UNITED STATES PATENT AND TRADEMARK OFFICE

APPLICATION NO.	FILING DATE	FIRST NAMED INVENTOR	ATTORNEY DOCKET NO.	CONFIRMATION NO.
10/642,346	08/18/2003	Joel Douglas	ICUMM3.7CPCPC	2054
20995 7590 06/15/2009 KNOBBE MARTENS OLSON & BEAR LLP 2040 MAIN STREET FOURTEENTH FLOOR IRVINE, CA 92614				
EXAMINER STIGELL, THEODORE J				
ART UNIT 3763		PAPER NUMBER		
NOTIFICATION DATE 06/15/2009		DELIVERY MODE ELECTRONIC

Office Action Summary

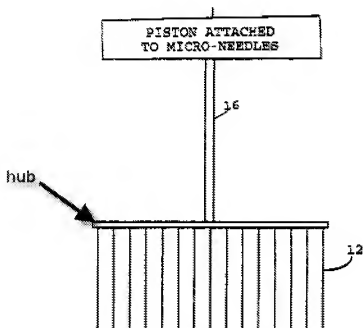
Claims 26-28, 30-32, and 65-66 are rejected under 35 U.S.C. 102(b) as being anticipated by Eriksson (US 5,697,901). Eriksson discloses a device for infusing a liquid comprising a hub (see drawing below) and a plurality of needles (12) extending from the hub in fluid communication with the hub wherein the needles are bent or curved at or near an end thereof (see tip 14), a connecting tube (16) attached to the hub and a pump (20) in fluid communication with the connecting tube, wherein the tube is in fluid communication with the needles, wherein the needles are arranged in an array, and the needles can form a pocket in the skin.
